Access Compliance Report

Public Rights-of-Way

(Curb Ramps)

Intersection ID: 47440	Main Street: ACCIPITER_WY	Cross Street: KALISPELL_LN	Location:	E
ADA ID: 9C3E43CAEA1E	Ramp Type: BlendTrans1	Initial Pass/Fail: Fail	Overall Compliance: No	Severity Score: 25

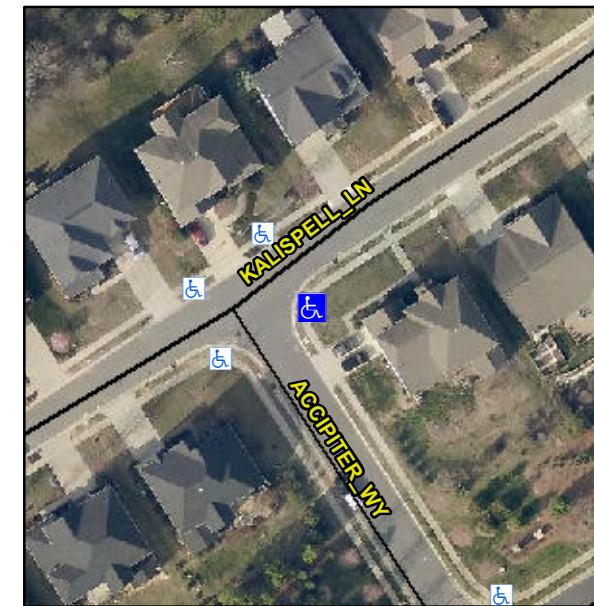
Not Found, R304.5.3

Compliance	Description	Data	Compliance	Description	Data
N/A	Ramp Length (in)	48.0	Yes	BlendTrans Slope (%)	2.7
Yes	Ramp Width (in)	48.0	No	BlendTrans XSlope (%)	7.5
N/A	Flare Type LT	N/A	N/A	Flare Type RT	N/A
N/A	Flare Slope LT (%)	N/A	N/A	Flare Slope RT (%)	N/A
N/A	Flare Traversable LT?	N/A	N/A	Flare Traversable RT?	N/A
N/A	Landing Length (in)	N/A	N/A	DWS Provided?	N/A
N/A	Landing Width (in)	N/A	N/A	DWS Contrast?	N/A
N/A	Landing Slope (%)	N/A	N/A	DWS Length (in)	N/A
N/A	Landing X Slope (%)	N/A	N/A	DWS Full Width?	N/A
N/A	Landing Curb? (Y/N)	N/A	N/A	DWS Offset (in)	N/A
N/A	Shared Landing?	N/A			
N/A	Gutter Ponding?	N/A	N/A	Gutter Slope (%)	N/A
N/A	Gutter Lip Ht (in)	N/A	N/A	Gutter X Slope (%)	N/A
N/A	Painted X Walk1?	No	N/A	Painted X Walk2?	No
	X Walk 1 Direction	To NW		X Walk 2 Direction	To SW
	X Walk 1 Width (in)	N/A		X Walk 2 Width (in)	N/A
	X Walk 1 Slope (%)	1.8		X Walk 2 Slope (%)	5.2
	X Walk 1 X Slope (%)	5.7		X Walk 2 X Slope (%)	2.1

N/A	Ramp inside XWalk1?	N/A	N/A	Ramp inside XWalk2?	N/A
	Road Slope (%)	7.1		Clear Space?	N/A
	Road X Slope (%)	2.0	N/A	Clear Space to XWalk (in)	N/A
N/A	Any Obstructions?	N/A	N/A	Storm Grate/Utility Hazard?	N/A
	Obstruction Type			Storm Grate/Utility Type	
		N/A			N/A
			Yes	Surface Condition? (G/P)	Good
			No	Curb Slope (%)	12.0

Remove & Replace Curb Ramp With Two New Directional Ramps or Equivalent.
